49-19

Schenectady, March 8, 1949

L. D. Miles
PURCHASING DEPARTMENT
Value Analysis Division

VALUE ANALYSIS DIVISION
PURCHASING DEPARTMENT
February 21, 1949

#13-1293 Stud

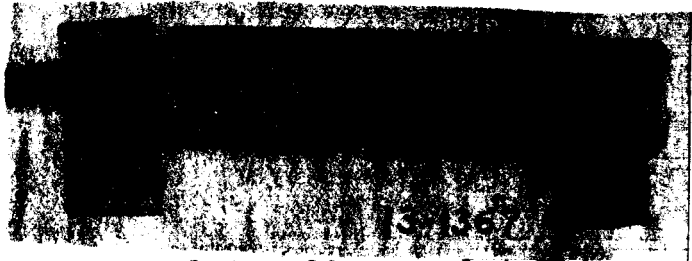
Present Shop Cost	lots 600	\$43.40/C
Outside Supplier's Quotation	lot 600	14.15
		(67% Reduction)
	lots 1200	11.35
		(74% Reduction)
